RE: Amended DA2022/1715 – 60 Hudson Pde Clareville NSW 2107

Letter of Objection on behalf of Mr Richard Utz 58 Hudson Parade

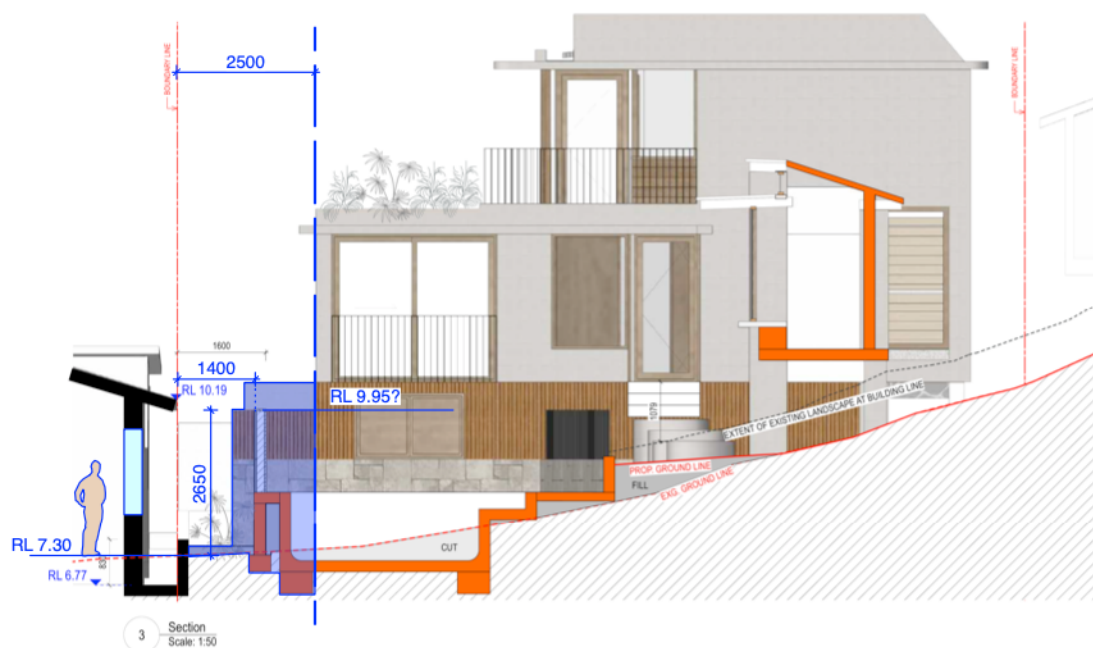
The existing bedroom windows located on the southern side of No. 58 will be greatly affected by the proposed location of the pool, pool deck and planters. The pool structure and fence is located 1.4m from the common boundary at a height of over 2.6m to 3.6m above Natural Ground level. The amended plans show that the pool deck has been lowered from R.L 9.0 to 8.5 however, with the height of the pool fence added, takes the height of this structure to the eaves of our house – which will have a huge impact on our property in terms of access to daylight and outlook from the bedroom windows. The Natural ground level in the entrance courtyard of our property is R.L 7.0. As stated in the DCP the required setback for the planter and pool deck structure on this boundary should be 2.5m. The amended plans note a setback of 1.6m (to the

inside face of the pool wall) which is 1.4m from the boundary. N.B The dwelling at No. 58 is not aligned with the boundary and, adjacent to the proposed pool is 700mm- 400mm from the boundary. See survey below.

The Ground floor bedrooms of no. 58 currently look onto the garden of No. 60 and are situated to the front of the house, away from main living areas and outdoor entertaining areas of no. 60, however the proposed location of the pool will mean that there will be NO visual or acoustic separation between the dwellings. Locating a primary outdoor area and pool raised significantly above natural ground will result in loss of daylight, visual and acoustic privacy and is in breach of the DCP and E4 Environmentally Sensitive Zoning.

We have overlayed the position of windows to existing bedrooms, F.F.L and boundary set-backs on the applicants sections through the pool in this location – which clearly indicates the height is **up to the eaves of the existing house** at a distance of 1.4m from the boundary.

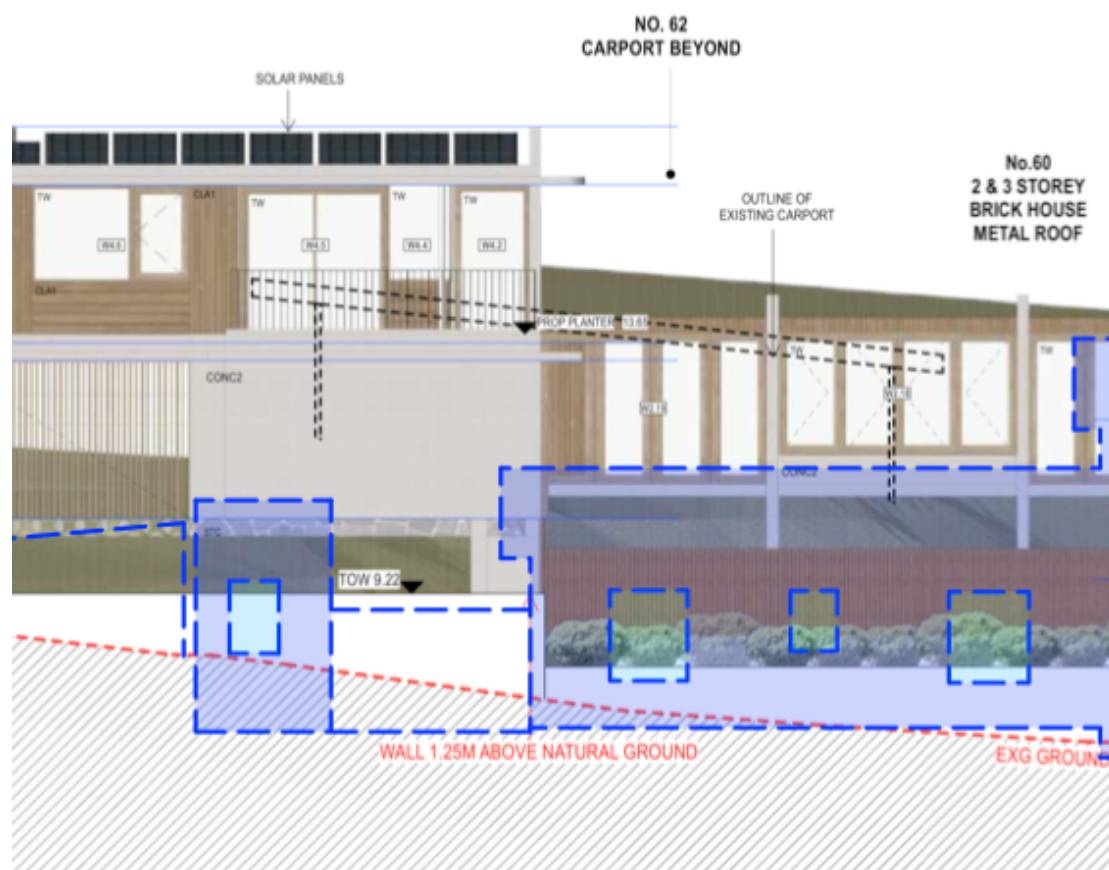
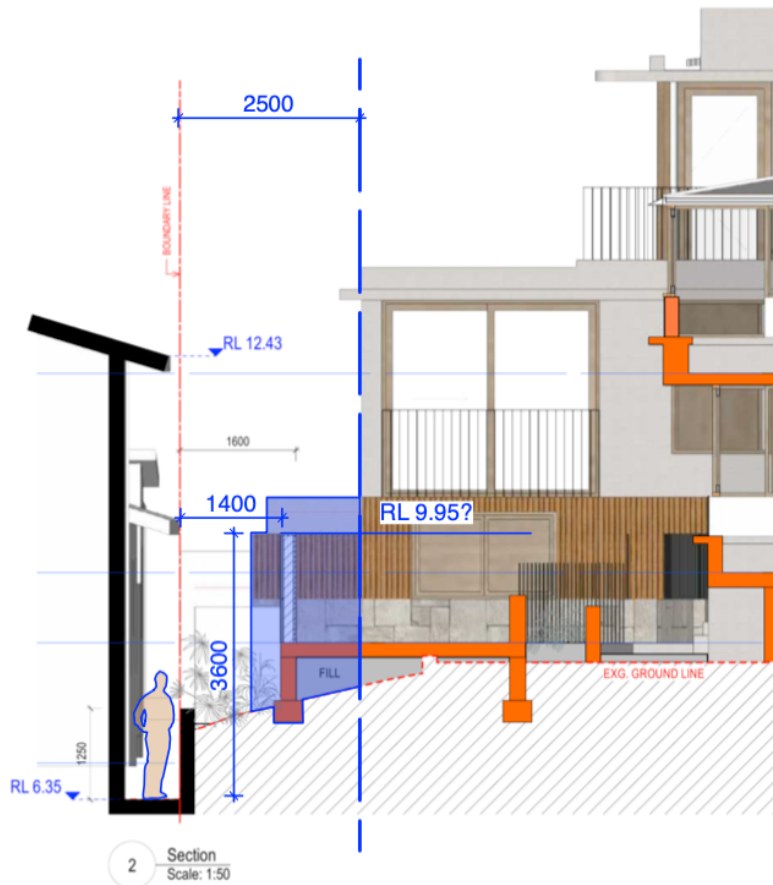
The amended pool deck is at a height of R.L 8.5 which is 1.5 metres higher than the existing courtyard level of no. 58 (R.L 7.0) the proposed retaining walls for the planter are located on the boundary at a height of 1.2-1.9m above natural ground level. The pool wall behind will then present a blank face along the entirety of our home on the southern boundary. This will have a huge impact on the existing bedrooms decreasing access to daylight and prevent any view of the sky or tree tops from these rooms. The bulk and scale will feel imposing and the narrow space between our house and these structures will be dark and uninviting.

See diagram of proposed in relation to No. 58 (bedroom windows shown in blue) which will look into a blank wall of the planter at a height of 2650mm above N.G.L at a minimum setback of 1 metre and maximum of 1.4m from the boundary.

The proposed Green Roof above the proposed games room and screen planting adjacent to the games room faces directly onto **the main entrance area and courtyard serving the guest bathroom and laundry of our property (referred to as rendered shed)**. The laundry and guest bathroom face a small courtyard and is where we shower after returning from the beach and is also the main entrance to the home. These private areas will now be overlooked from the proposed additions.

Below is an overlay of No. 58 and the location of windows in relation to the proposed retaining walls and pool structures. The elevation below clearly illustrates that the pool fence is equivalent to the eaves height of No 58 and is well above the windows. The position of the terrace adjoining the games room, look directly over the front courtyard and patio of No. 58.

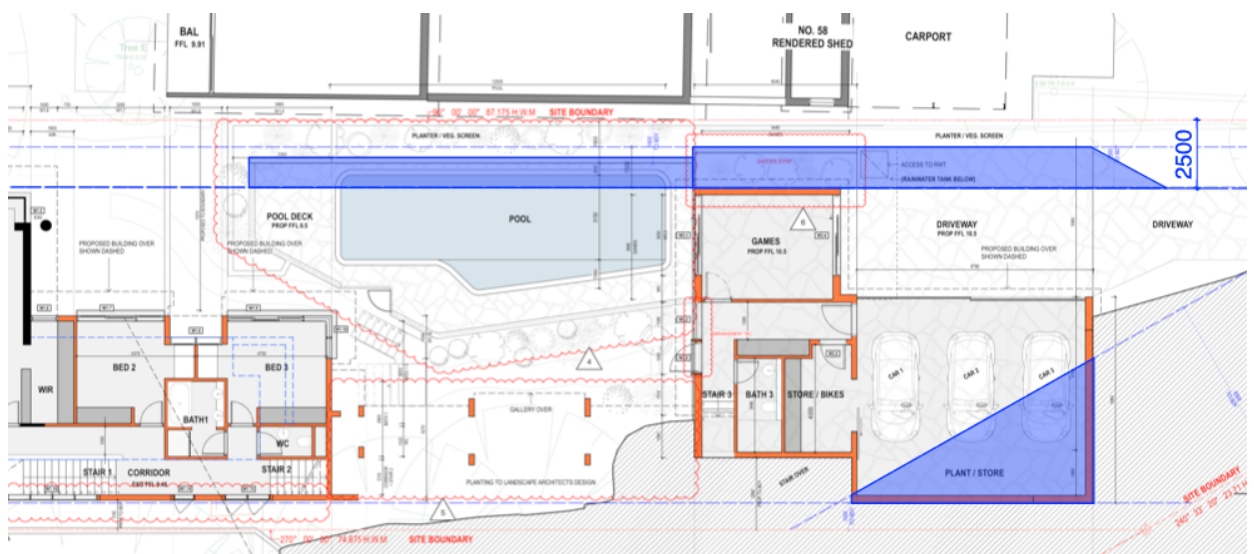
The side setback on the northern boundary of the subject site should be a minimum of 2.5m and is not in accordance with this clause. The setback on the southern boundary is measuring at 1.4m noted as 1.6m to the internal face of pool wall. Note the position of the existing dwelling of No. 58 in relation to the common boundary (less than 900mm along the entire southern elevation).

- satisfactory landscaping within the setback from the pool or spa coping to the side or rear boundary, and **(Does not achieve)**
- Council is satisfied that the adjoining properties will not be adversely affected, and
- the pool or spa is not more than 1 metre above ground level (existing), and **(Does not comply)**
- that the outcomes of this clause are achieved without strict adherence to the standards, and
- where the site constraints make strict adherence to the setback impractical, and **(Does not comply)**
- where strict compliance with these requirements will adversely impact on the views of adjoining residential properties. **(Impacts on views and daylight access)**

Areas shaded in blue are outside of Council's required set-backs.
